# Access Compliance Report

## Public Rights-of-Way

### (Curb Ramps)

Intersection ID: 10024242	Main Street: COY_CT	Cross Street: N/A	Location: S
ADA ID: ABD62B43AF39	Ramp Type: Perp	Initial Pass/Fail: Fail	Overall Compliance: No
		Severity Score: 8.75	
Codes/Mitigation Info/Possible Solution		Field Measurements/Component Compliance

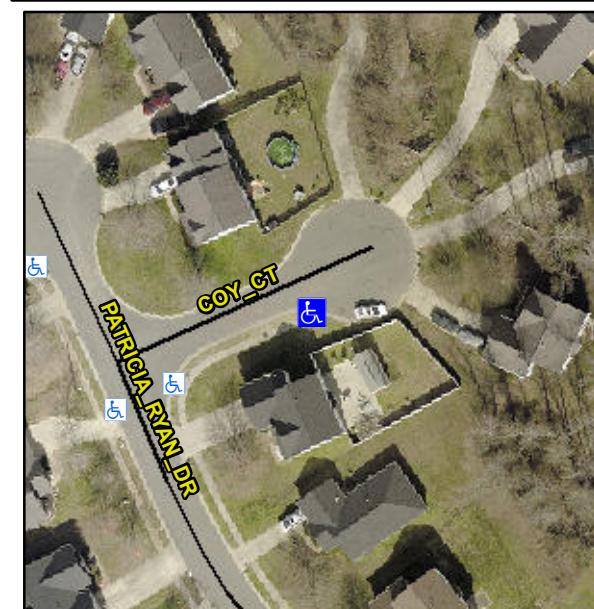
**R304.5.1**

Compliance	Description	Data	Compliance	Description	Data
N/A	Ramp Length (in)	48.0	Yes	Ramp Slope (%)	5.2
No	Ramp Width (in)	46.5	Yes	Ramp XSlope (%)	1.4
N/A	Flare Type LT	N/A	N/A	Flare Type RT	N/A
N/A	Flare Slope LT (%)	N/A	N/A	Flare Slope RT (%)	N/A
N/A	Flare Traversable LT?	N/A	N/A	Flare Traversable RT?	N/A
N/A	Landing Length (in)	N/A	N/A	DWS Provided?	N/A
N/A	Landing Width (in)	N/A	N/A	DWS Contrast?	N/A
N/A	Landing Slope (%)	N/A	N/A	DWS Length (in)	N/A
N/A	Landing X Slope (%)	N/A	N/A	DWS Full Width?	N/A
N/A	Landing Curb? (Y/N)	N/A	N/A	DWS Offset (in)	N/A
N/A	Shared Landing?	N/A			
N/A	Gutter Ponding?	N/A	N/A	Gutter Slope (%)	N/A
N/A	Gutter Lip Ht (in)	N/A	N/A	Gutter X Slope (%)	N/A
N/A	Painted X Walk1?	No	N/A	Painted X Walk2?	N/A
	X Walk 1 Direction	To N		X Walk 2 Direction	N/A
N/A	X Walk 1 Width (in)	N/A	N/A	X Walk 2 Width (in)	N/A
	X Walk 1 Slope (%)	0.8		X Walk 2 Slope (%)	N/A
	X Walk 1 X Slope (%)	3.8		X Walk 2 X Slope (%)	N/A

**Remove & Replace Entire Ramp.**
